593 & 601-603 Laurier Avenue West

UDRP REPORT
Official Plan and Zoning By-law Amendment Applications
June 15, 2025

URBAN DESIGN BRIEF

601 LAURIER AVENUE

Current Massing

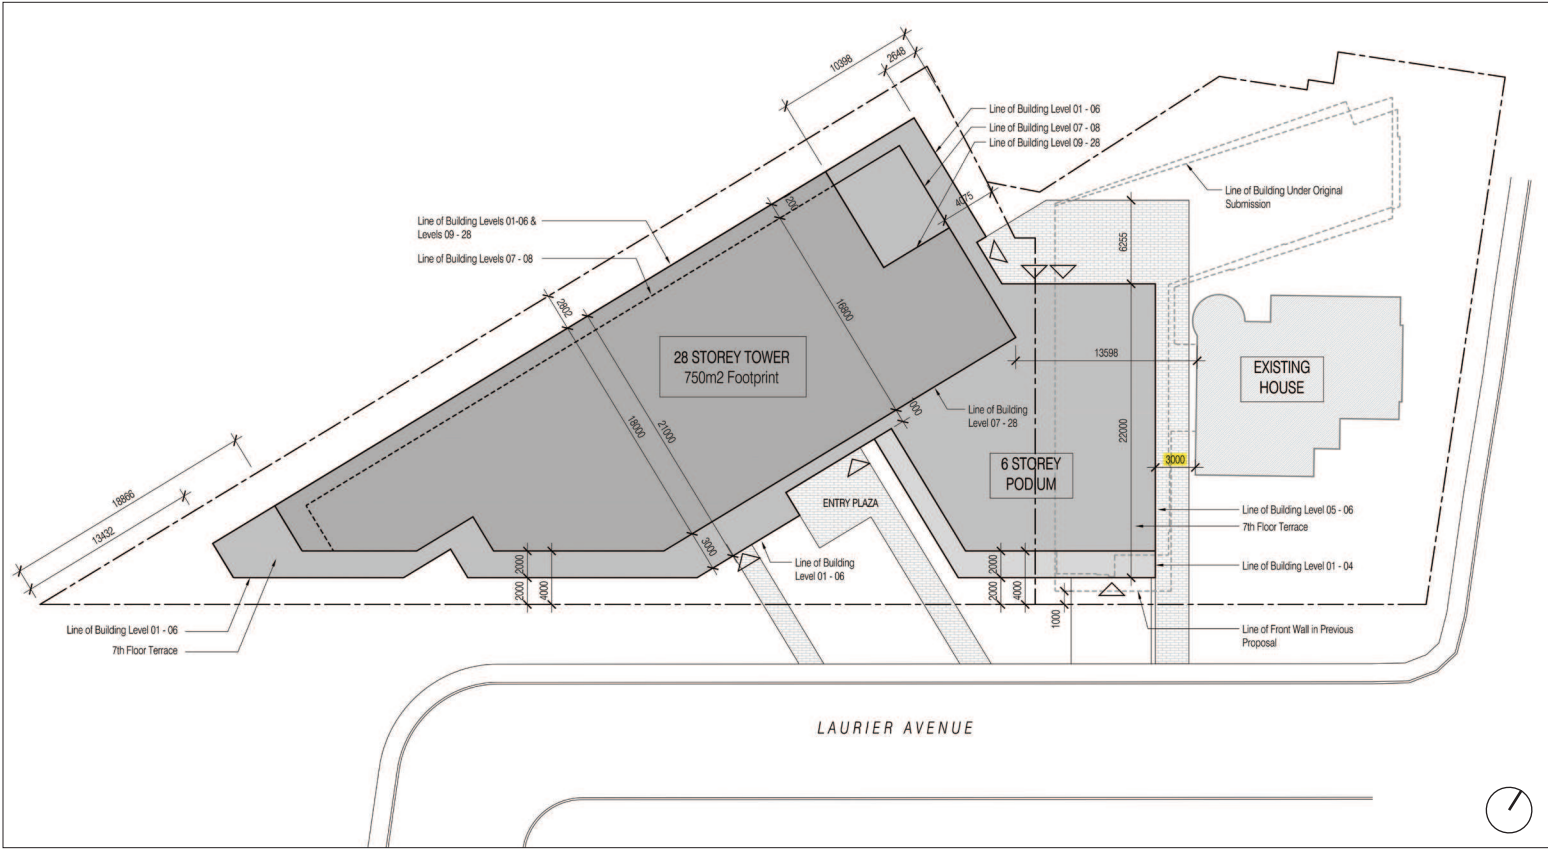
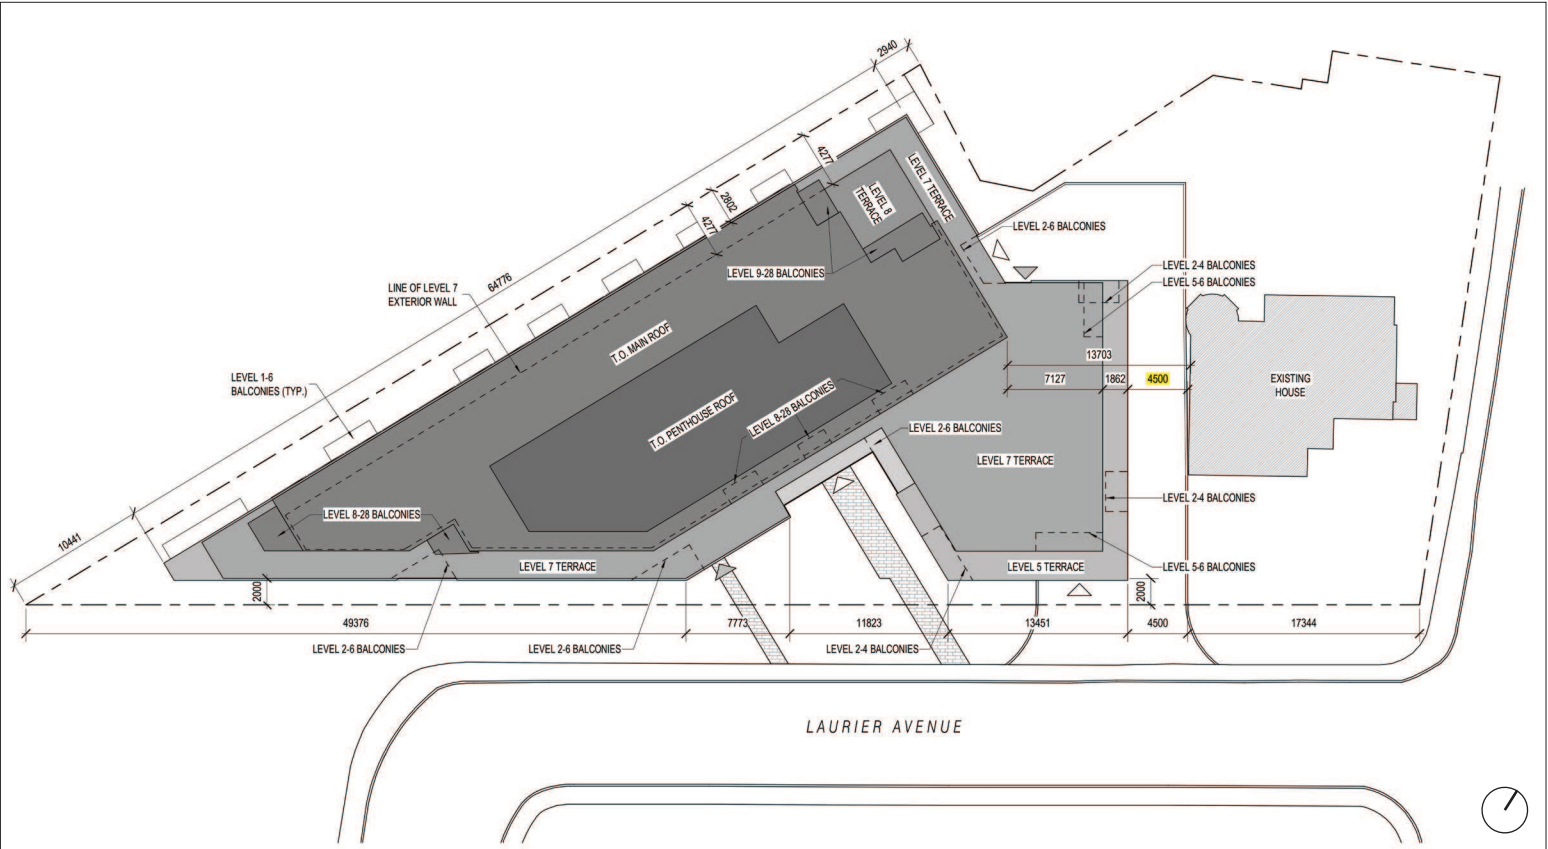
The podium may be high for the neighbourhood context and especially the relationship to the heritage house on the property. We recommend providing additional design/massing details so we may better understand the approach being taken.

We have increased the separation from the heritage house to 4.5m from 3m and introduced a setback and material change above level 4 to better integrate the podium with the neighborhood context. These adjustments help to mitigate the podium height and ensure a more harmonious relationship with the heritage house.

The initial massing concept positioned the proposed development 3 meters from the existing Heritage House for the first six storeys of the podium. This approach was primarily driven by the objective to maximize leasable space, providing ample room for residential units while maintaining vehicular access to essential building services at the rear. This configuration, however, raised concerns about the proximity to the Heritage House and its impact on both the historical context and practical access, and required further consideration to improve spatial dynamics and circulation.

In response to these concerns, the current design iteration has been refined to enhance both spatial and aesthetic relationships. The podium has been shifted an additional 1.5 meters away from the Heritage House, resulting in a total separation of 4.5 meters. Furthermore, levels five and six of the podium are now recessed an additional 1.8 meters, creating a more gradual transition to the tower levels above. The first four levels of the podium, which align with the height of the Heritage House, will feature red-tone brick complimenting the red brick of the existing structure. This material choice reinforces the architectural dialogue between the new and existing building.
